**SUBJECT:** **Alteration to a Listed Heritage Property**  
**1276 Clarkson Road North (Ward 2)**

***HERITAGE IMPACT STUDY***  
***IMPACT OF PROPOSED RESIDENTIAL ADDITION***  
***1276 CLARKSON RD. N., MISSISSAUGA***

**SUBJECT:** **Alteration of a Designated Part V Property**  
**Meadowvale Village Heritage Conservation District**  
**1074 Old Derry Road**  
**(Ward 11)**

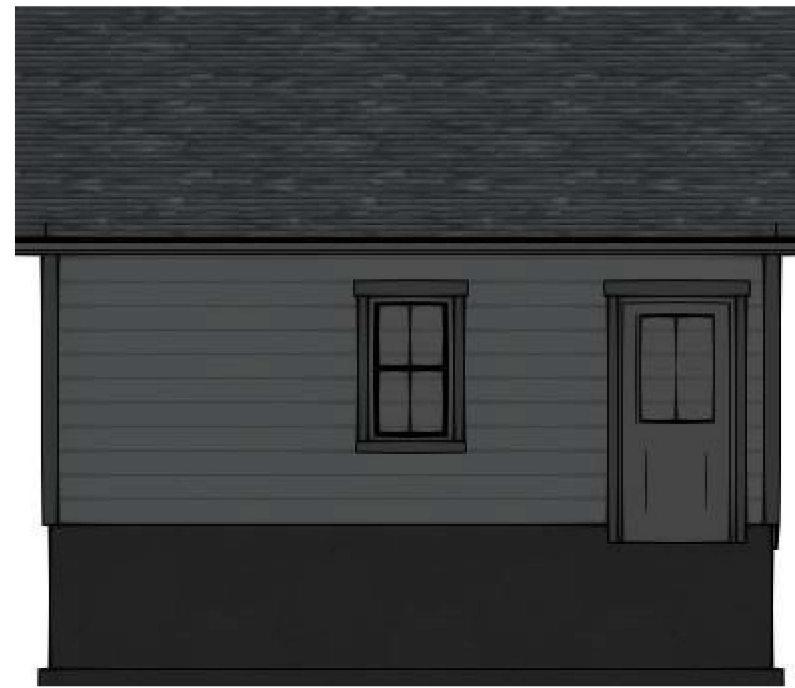
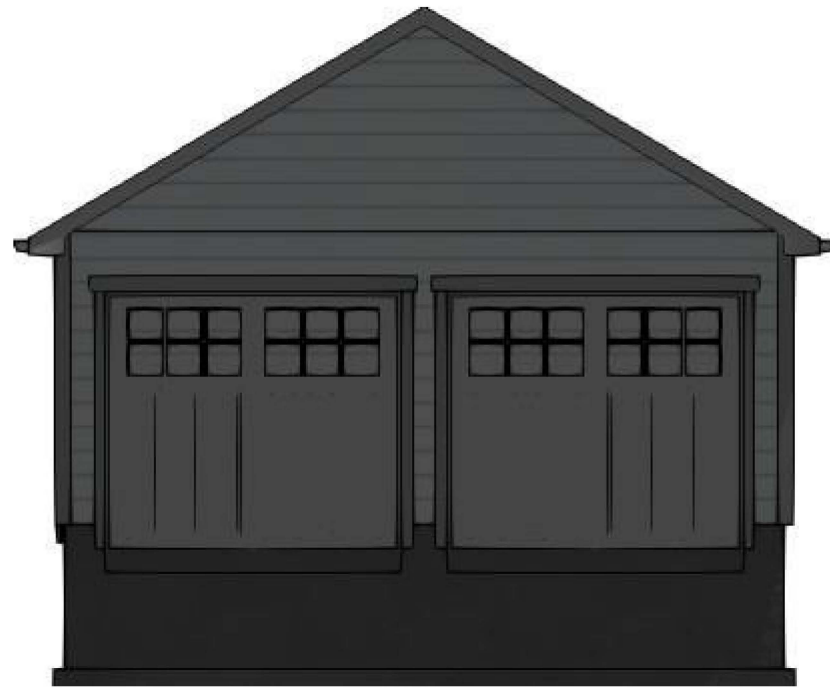
Heritage staff, in conjunction with the Meadowvale Village Heritage Conservation District Review Committee, (Appendix 2), reviewed the application to construct a stand-alone, one-storey, two-car garage on this property, per the criteria outlined in the city's Conservation Principles and Design Guidelines for the Meadowvale Village Heritage Conservation District, 2003. Specifically, addressing item #16 which indicates that 'Garages must be detached structures and should be located to the side or rear of the house.' Further, "As an outbuilding, the garage should be smaller than the house in all of its dimensions." The applicant's proposal satisfies these requirements.

Therefore, Heritage Planning staff recommends approval of the alteration application, to allow for the construction of a stand-alone, one-storey, two-car garage.
